SUBJECT: Responds to NRC 901217 ltr re violations noted in Insp Rept
 50-259/90-33, 50-260/90-33 & 50-296/90-33. Corrective actions:
 TVA has revised its reportability determination.

BROWNS FERRY NUCLEAR PLANT (BFN) - NRC INSPECTION REPORT 50-259, 260,
296/90-33 - RESPONSE TO NOTICE OF VIOLATION

RESPONSE - BROWNS FERRY NUCLEAR PLANT (BFN)
NRC INSPECTION REPORT 50-259, 260, 296/90-33
LETTER FROM B. A. WILSON TO O. D. KINGSLEY, JR.
DATED DECEMBER 17, 1990

EXAMPLE B - RELAY LOGIC DIAGRAM

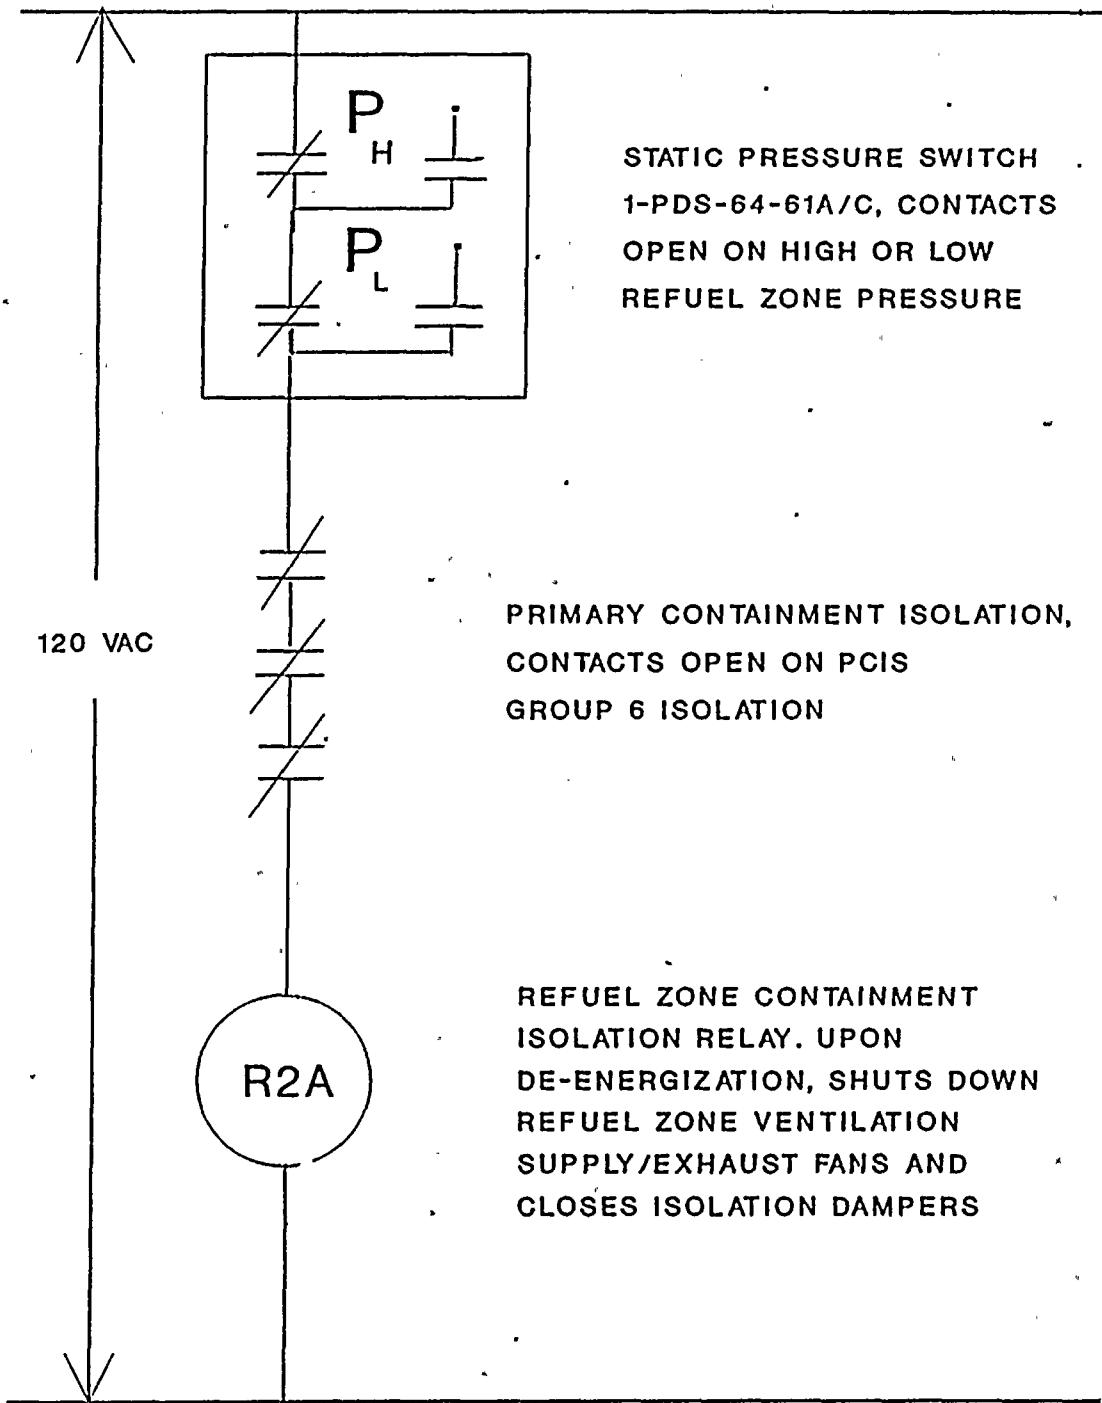
The event described in this example was not reported as an unplanned ESF actuation because no ESF logic was actuated during the event. The Refuel Zone Ventilation System fans and isolation dampers are dual function components. First, the refuel zone ventilation fans are shutdown and the dampers closed to isolate secondary containment upon receipt of a PCIS Group 6 isolation signal. Second, they are utilized for pressure control of the ventilation zones.

A PCIS Group 6 isolation signal is developed when any of the following conditions exist: low reactor vessel water level, high drywell pressure, or high radiation in the reactor zone. At the time of the event, none of the ESF logic (either spurious or valid) associated with any of these three conditions was actuated.

At the time the PCIS Group 6 signal was received, TVA investigated the event and determined that the refuel zone isolation was initiated by the spurious action of the refuel zone static pressure switch 1-PDS-64-611B/D. This switch is not associated with the ESF, but is designed to protect the Reactor Building zones from excessive positive or negative pressures. Further, this switch is nonsafety-related and is not required to perform a safe shutdown function. The relationship of the zonal pressure switch logic to the PCIS logic is shown on Enclosure 3. As depicted on the diagram, the static pressure switch logic is independent of the PCIS logic. The refuel zone isolation characterized by this event was an expected non-ESF response to a spurious actuation of a refuel zone zonal pressure switch.

Since the refuel zone isolation resulting from the static pressure switch failure was not a valid ESF signal, TVA determined this event to be not reportable per 10 CFR 50.72 or 10 CFR 50.73, and made this determination within four hours of receiving the isolation signal.
